HOPE CREEK GENERATING STATION  
DOCKET NO. 50-354  
FSAR COMMITMENT STATUS THROUGH JULY 1984

ATTACHMENT I  
HOPE CREEK GENERATING STATION  
FSAR COMMITMENT STATUS THROUGH JUNE 1984

FIGURE 9.1-3

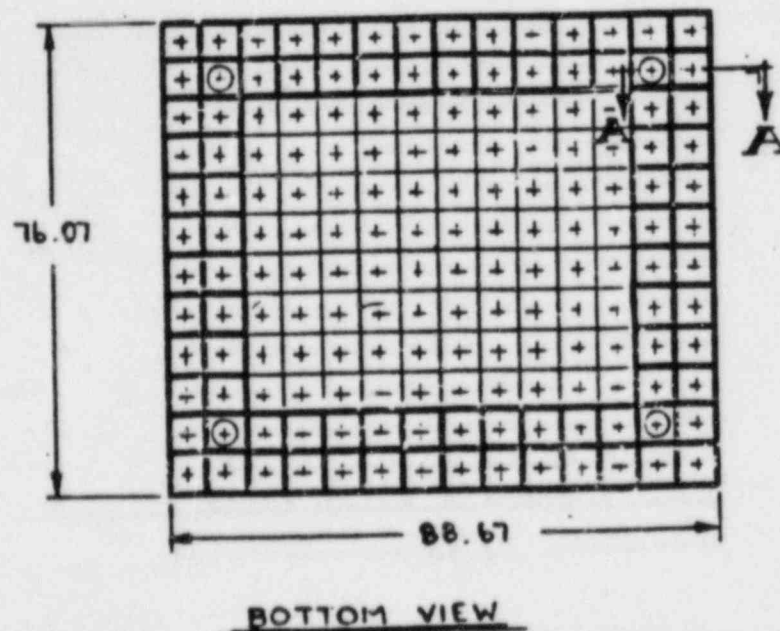
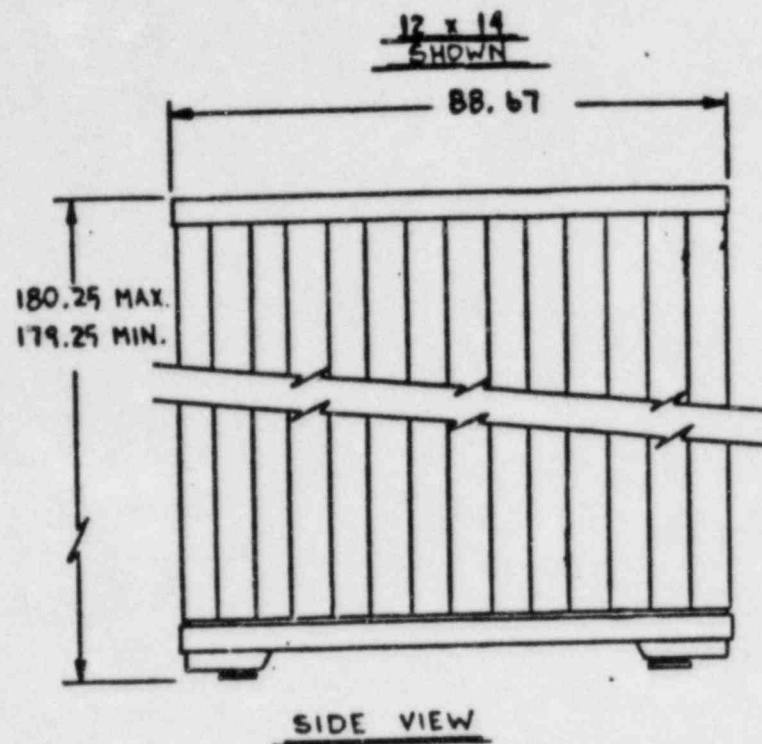
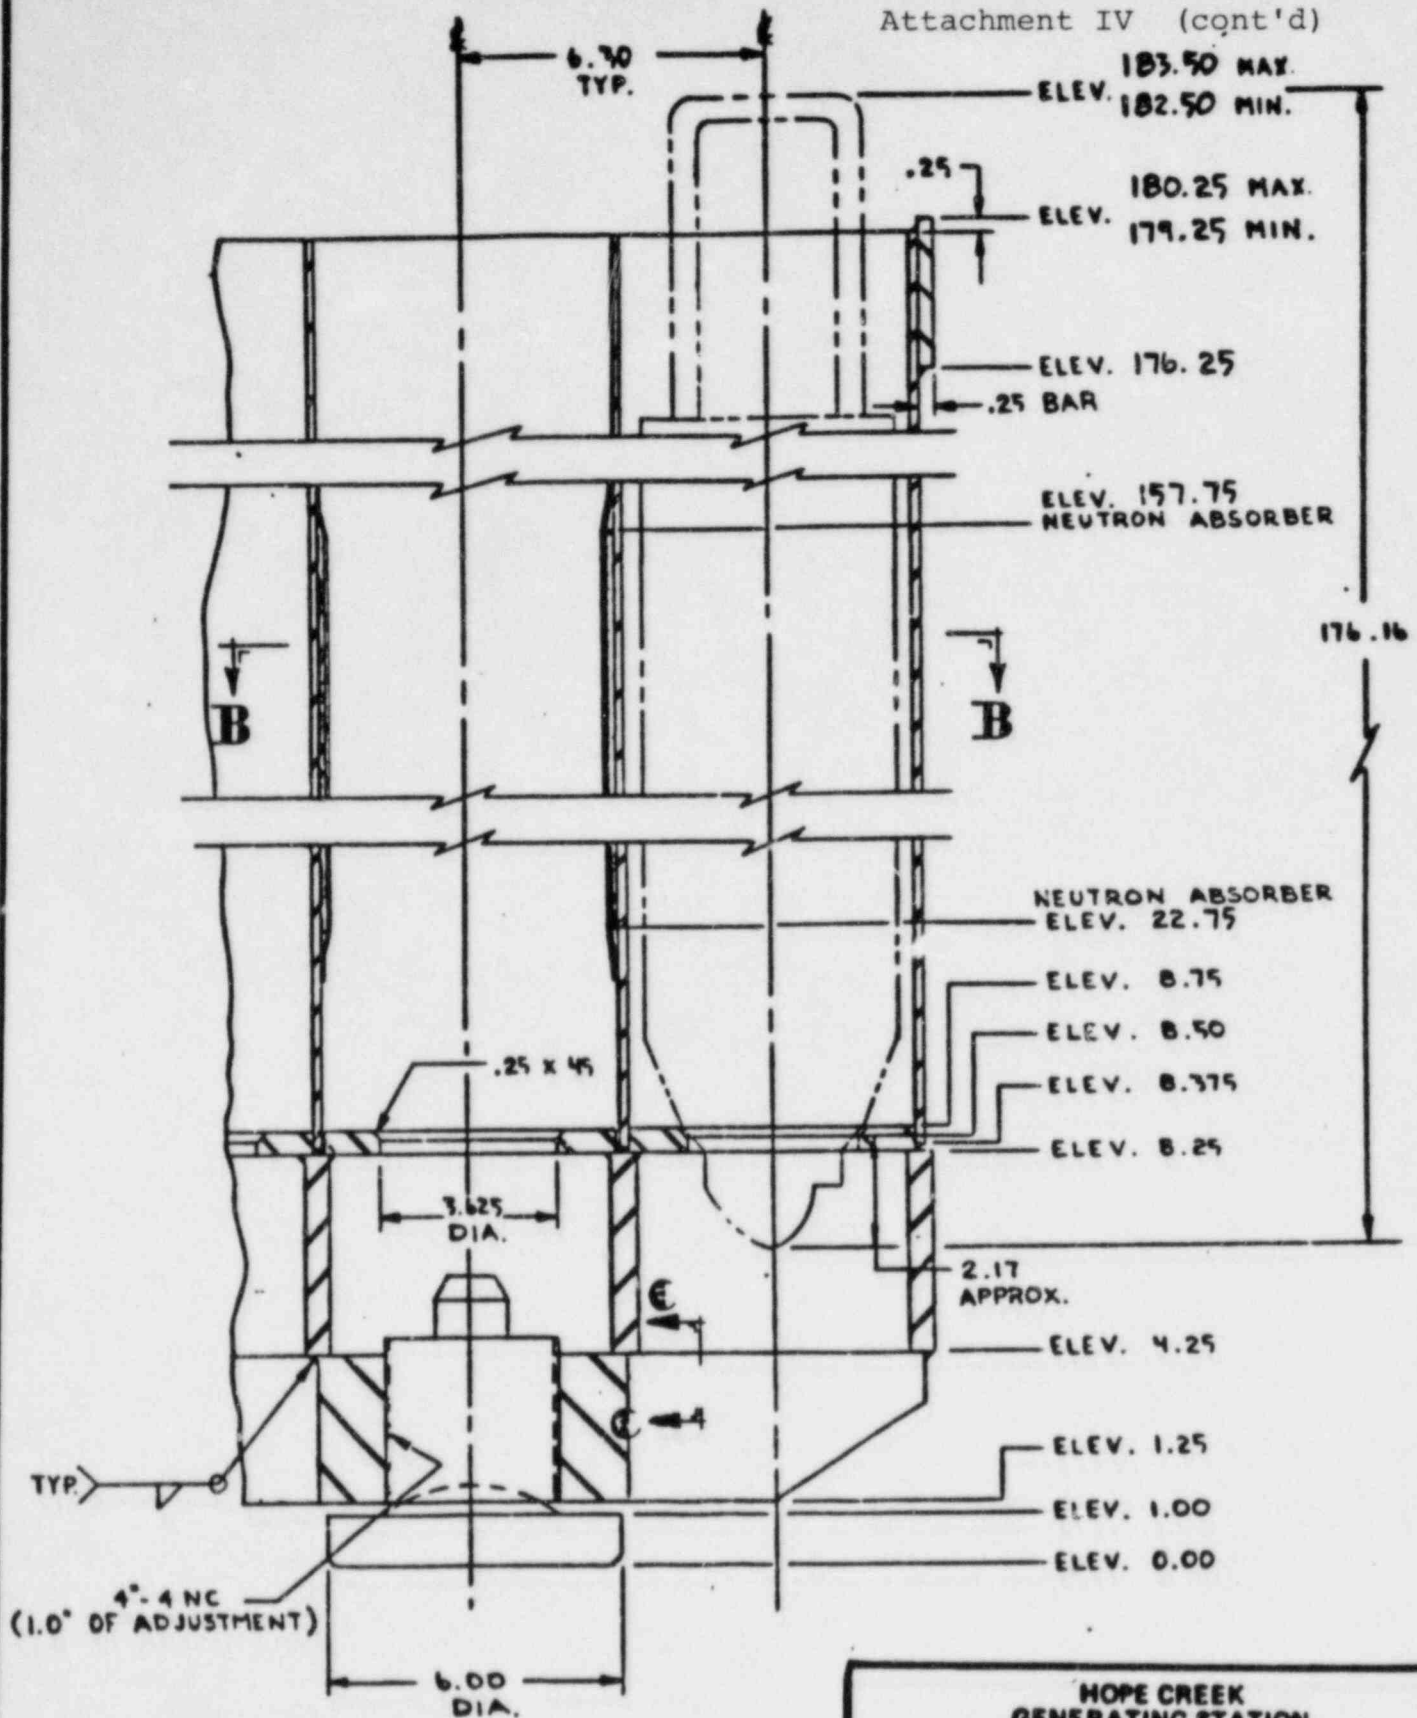
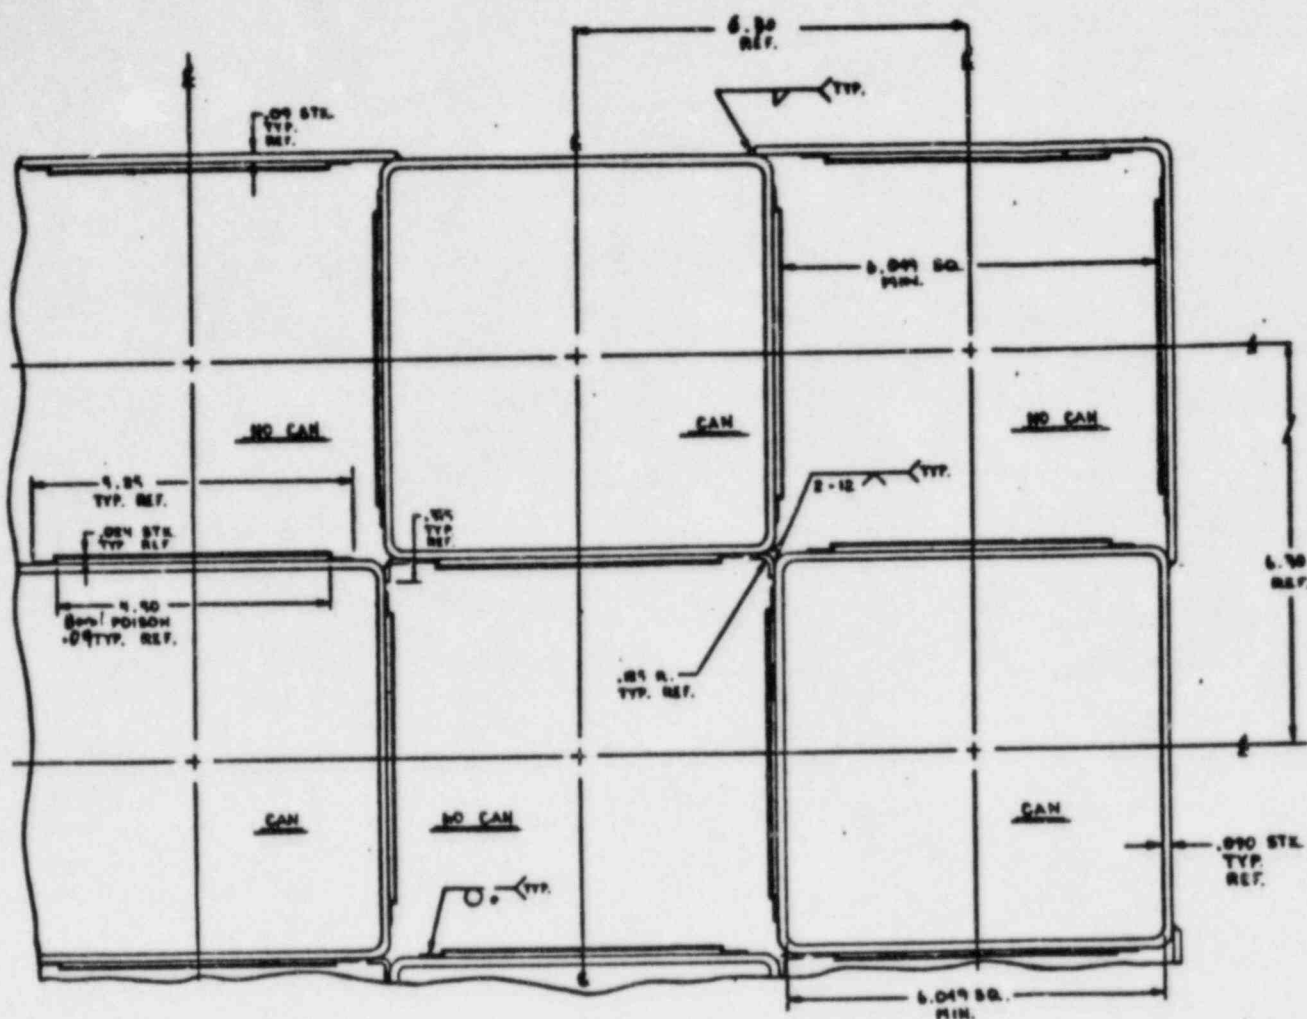
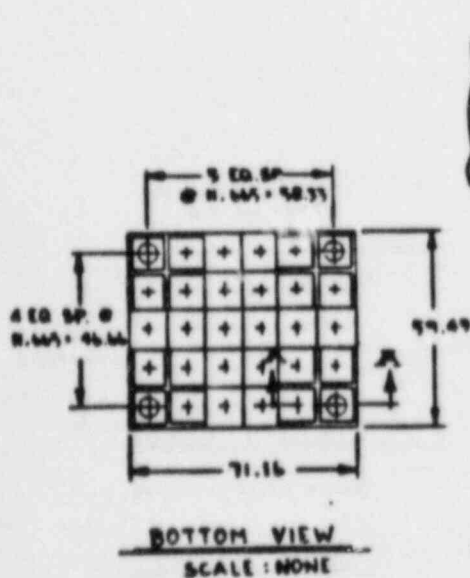
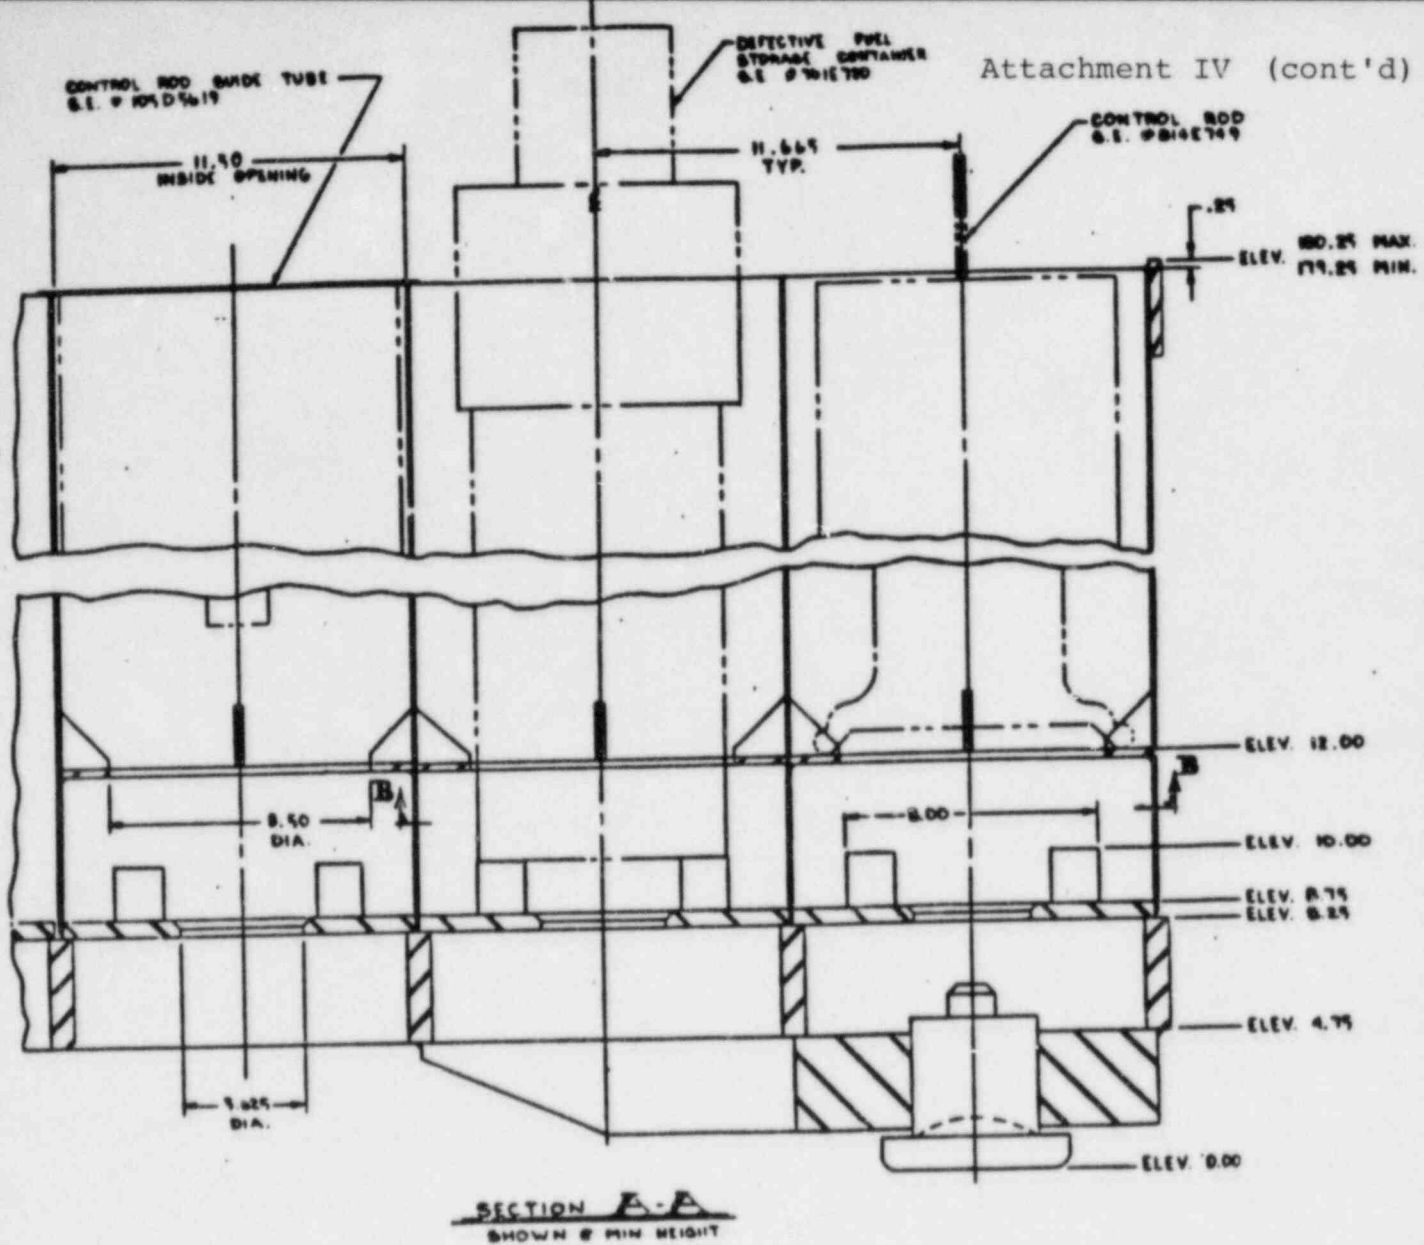
Figures 9.1-3 and 9.1-4 are shown as to be supplied later.  
Supply these figures or a date by which they will be provided.

Without the spent fuel storage rack design details, the results of an analysis of impact onto the racks and the bundle-to-bundle fuel spacing, the staff cannot make any favorable conclusions about the design. Provide this information in the FSAR.

Section 9.1.2 has been revised to provide  
Figure 9.1-3, A Typical Spent Fuel Rack, and Figure 9.1-4, Spent  
Fuel Rack Arrangement In Fuel Pool. ~~will be provided by June 1~~  
~~1988.~~

Section 9.1.2 and Figure 9.1-3 have been revised to include  
^ The spent fuel rack design details. ~~will be available by June~~  
~~1984, and will be added to Section 9.1.2.~~
